South King Fire and Rescue

Station 63 Facility Improvements

ADDENDUM #1

December 16, 2016

A10.01

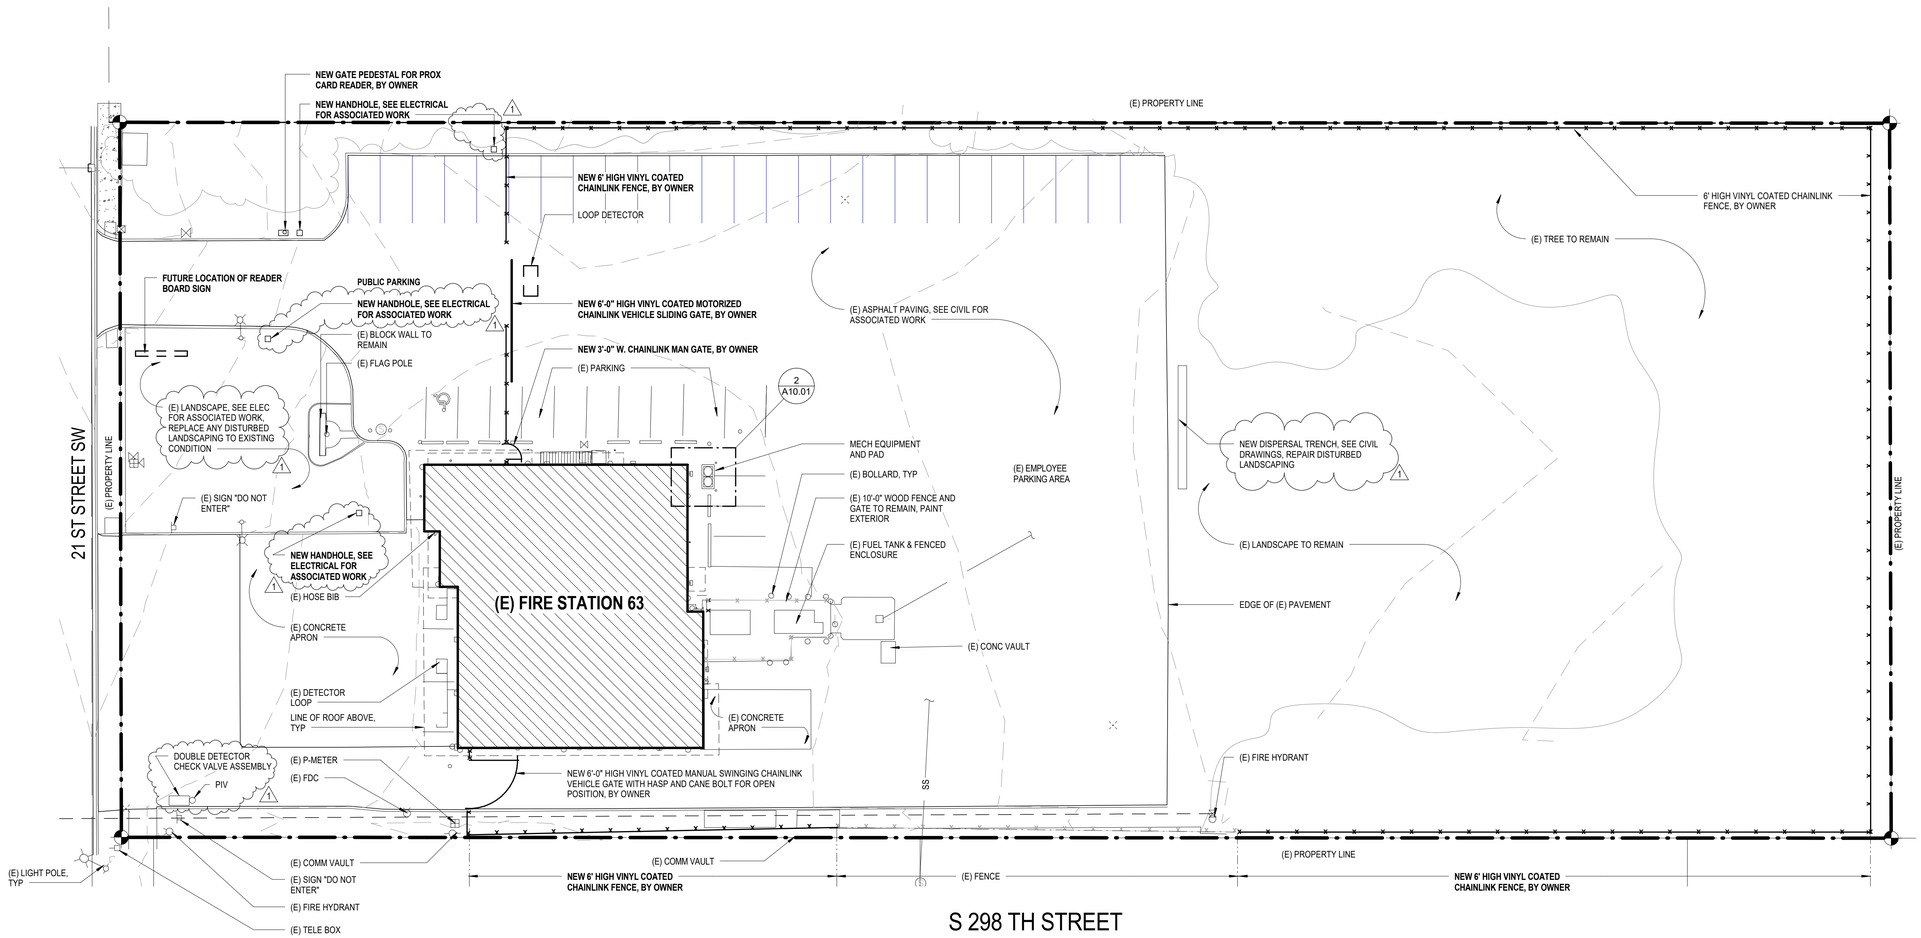
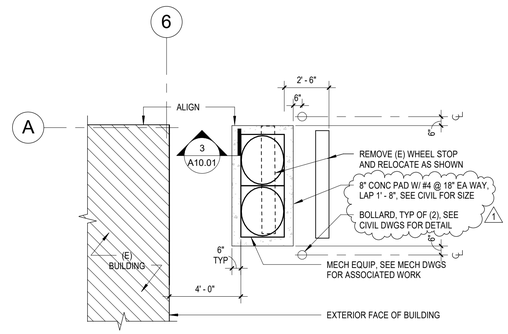
ITEM 2.	A10.01	See clouded revisions on attached drawing.
ITEM 3.	A21.01	Room 112, ADD note to existing register grille "REMOVE (E) EXIST REGISTER GRILLE".
ITEM 4.	A21.01	Room "SR5 108", ADD Keynote "D3".
ITEM 5.	A21.01	Room "SR5 108", ADD note "DEMO (E) FLOOR GRILL PER MECH, FILL OPNG WITH CONCRETE FLUSH WITH (E) FLOOR SLAB, TYP.
ITEM 6.	A21.12	See clouded revisions on attached drawing.
ITEM 7.	A21.11	Room "SR5 108", ADD New carpet CPT-1 and base RB-1 shall be installed.

C2.00

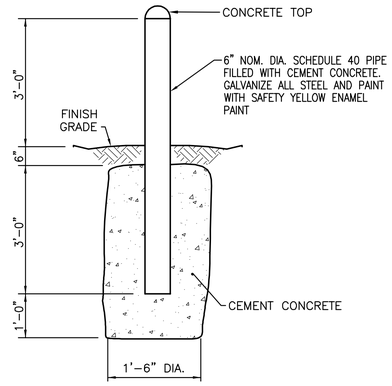
ITEM 8.	C2.00	See clouded revisions on attached drawing.
ITEM 9.	C3.01	See clouded revisions on attached drawing.

ITEM 37. E101 Provide a ¾" conduit from the new fire alarm panel out to the post indicator valve at the southwest corner of the property. See sheet C2.00, construction note 5 for location.

S21.11

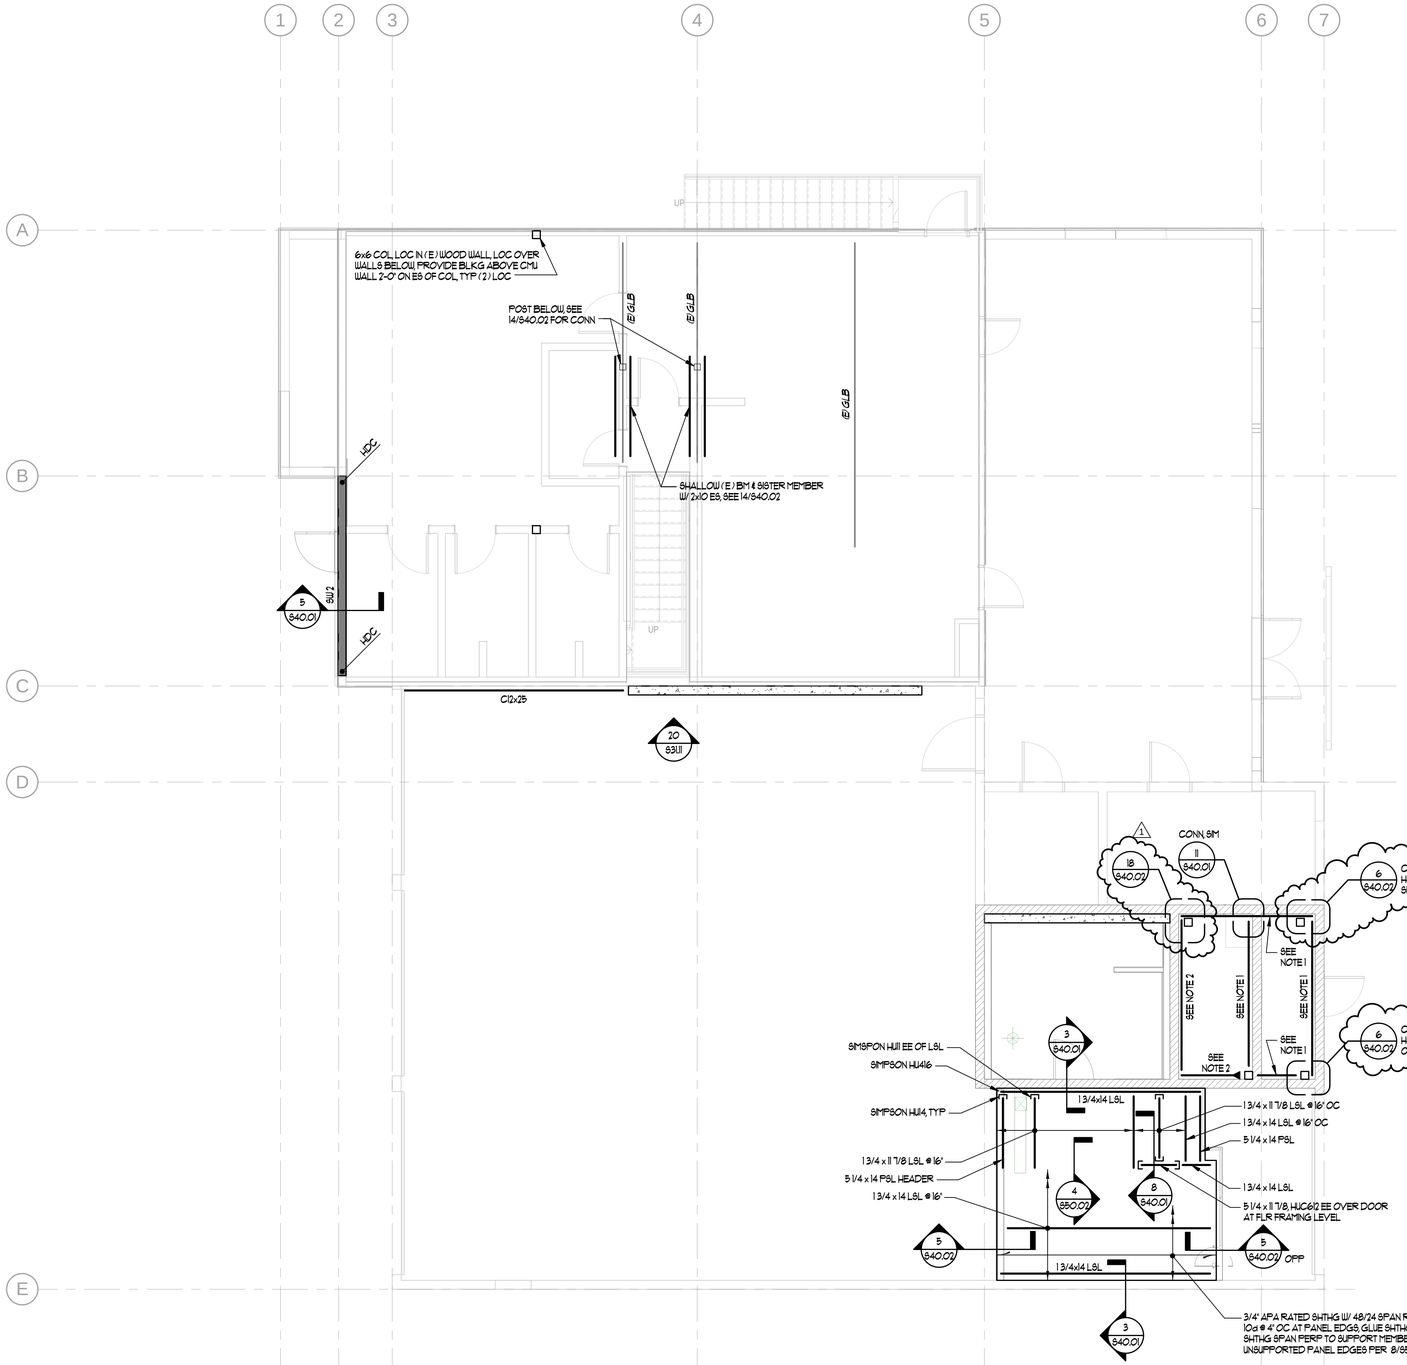
ITEM 10.	S21.11	See clouded revisions on attached drawing.
ITEM 11.	S22.11	See clouded revisions on attached drawing.

S23.11

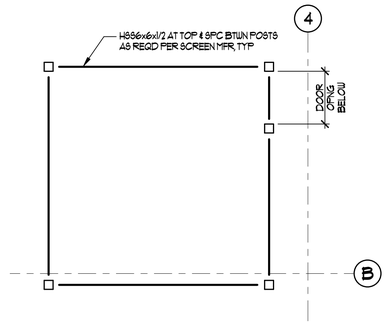
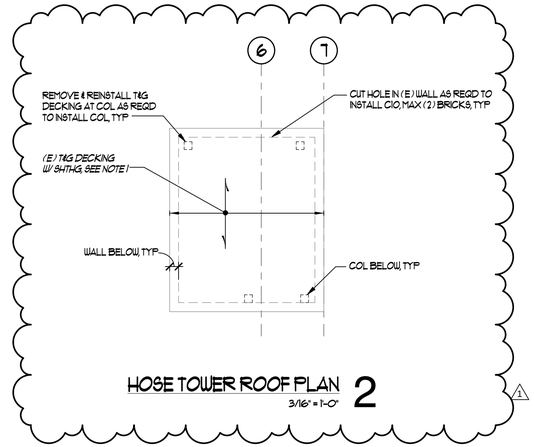
ITEM 12. S23.11 See clouded revisions on attached drawing.
ITEM 13. S40.01 See clouded revisions on attached drawing.
ITEM 14. S40.02 See clouded revisions on attached drawing.
ITEM 15. S50.01 See clouded revisions on attached drawing.

M40.01

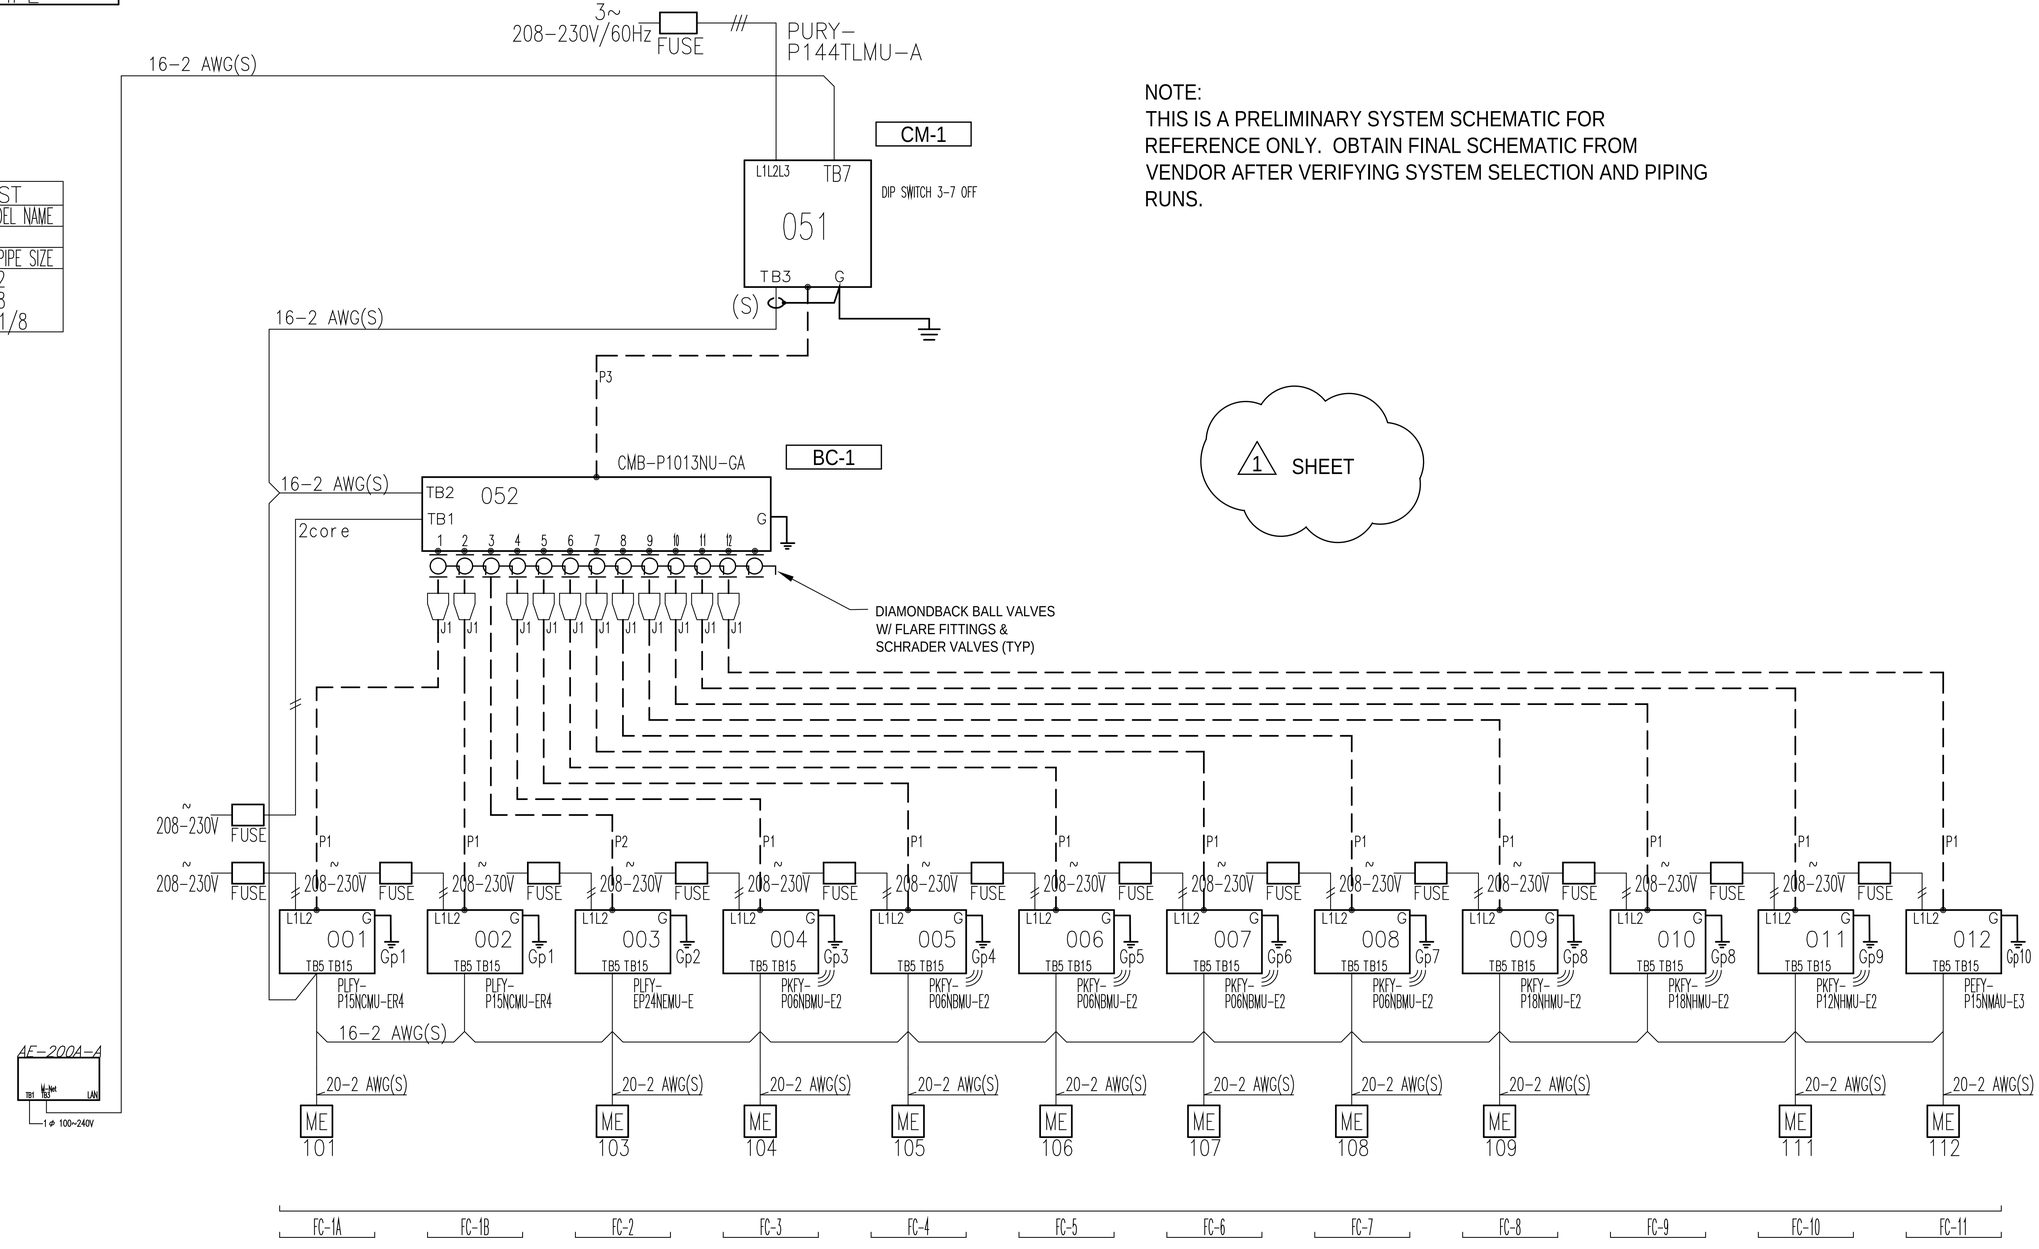
ITEM 25. M40.01 **Revise** VRF Diagram. See revised M40.01.

MSK-1

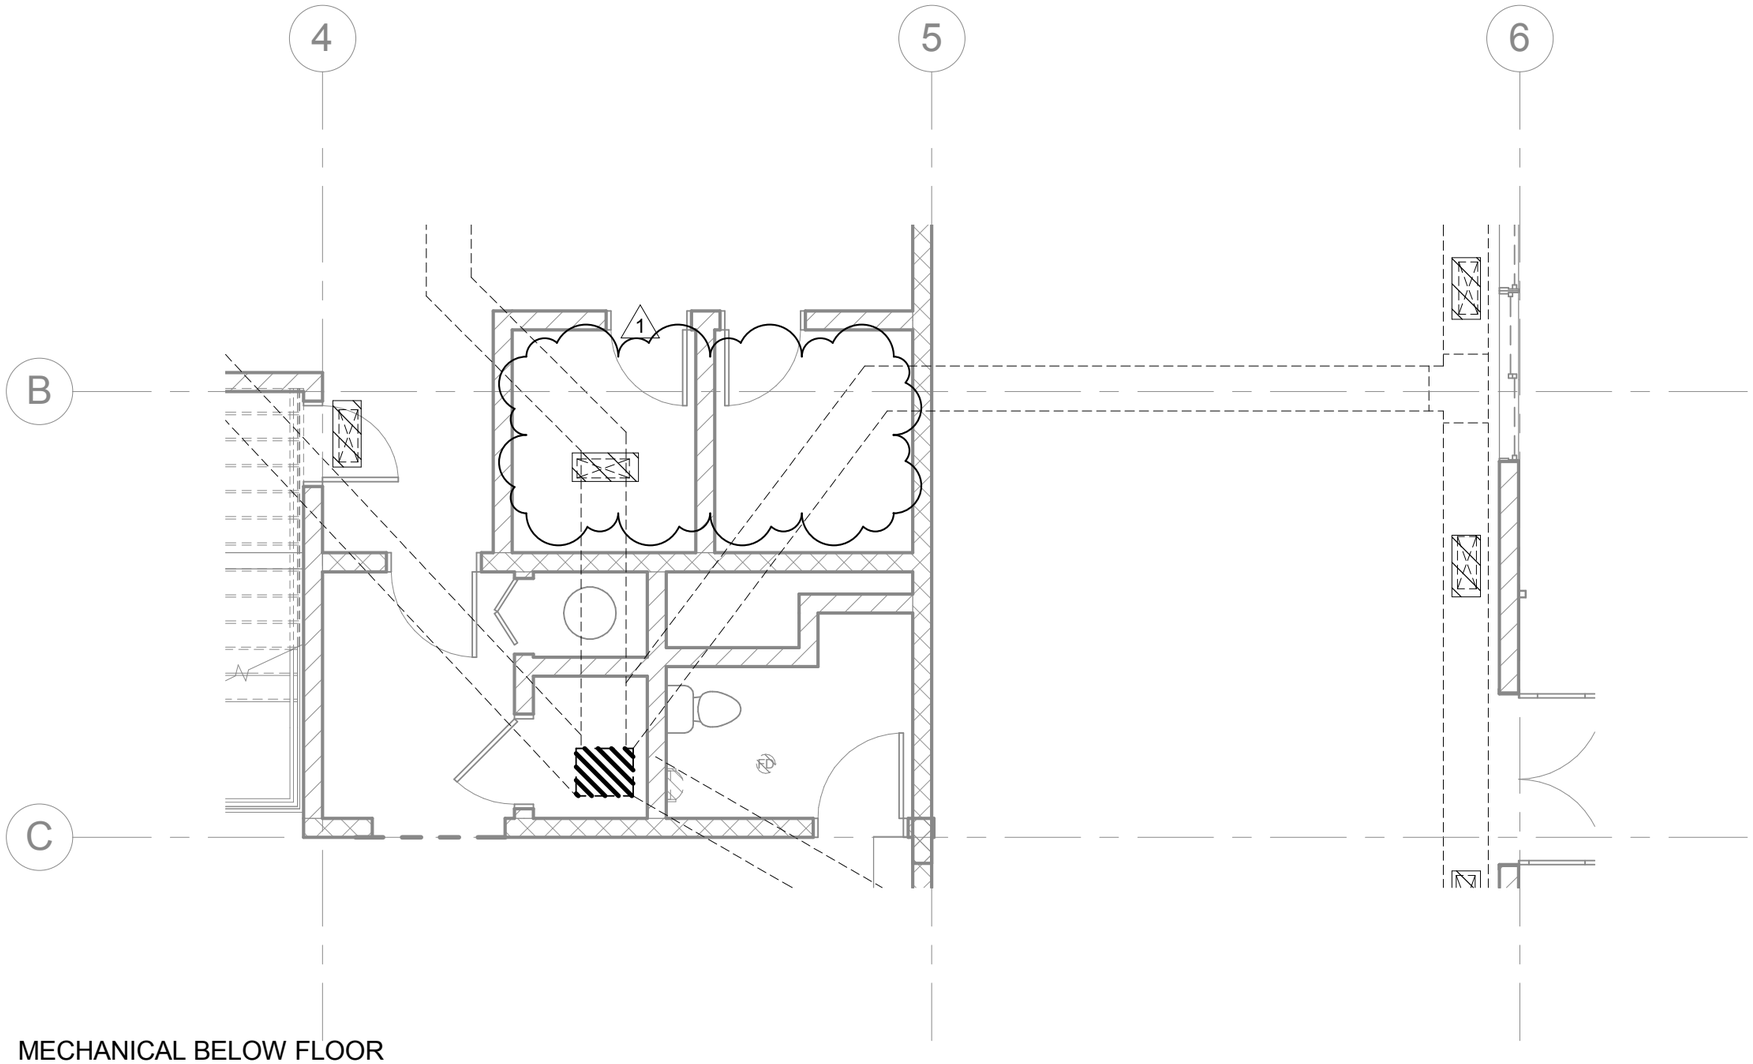
ITEM 21. M20.10 **Revise** location of existing floor grille to be removed, see MSK-1.

MSK-2

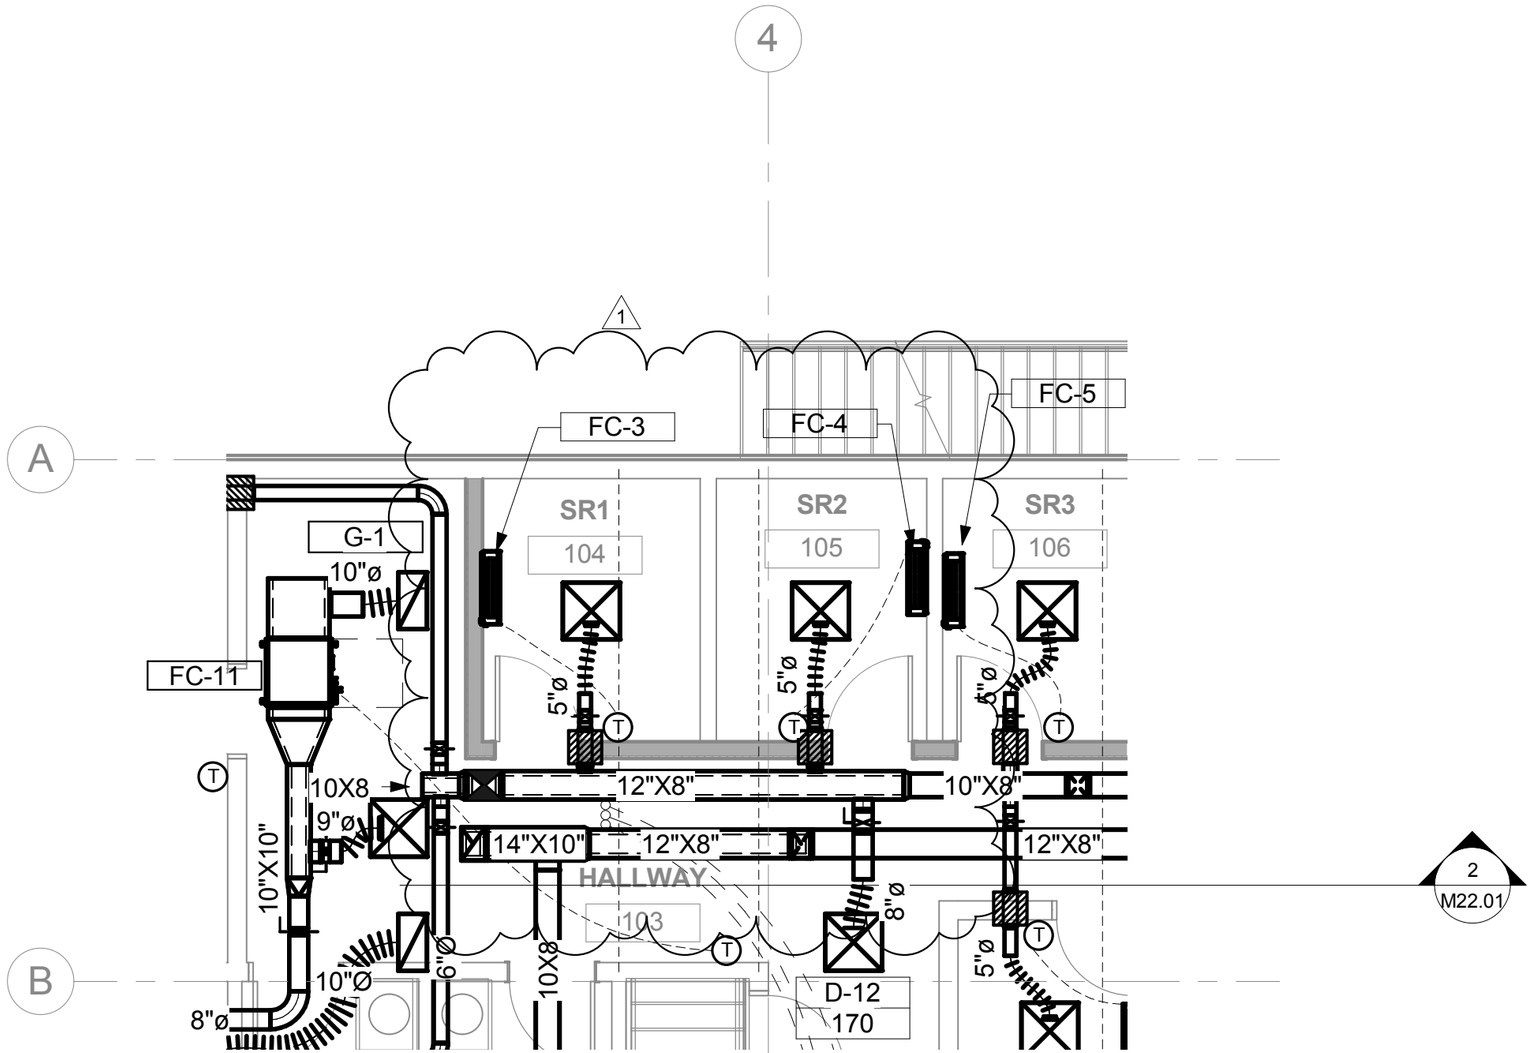
ITEM 22. M21.11 **Revise** location of FC-3 and FC-4, see MSK-2.
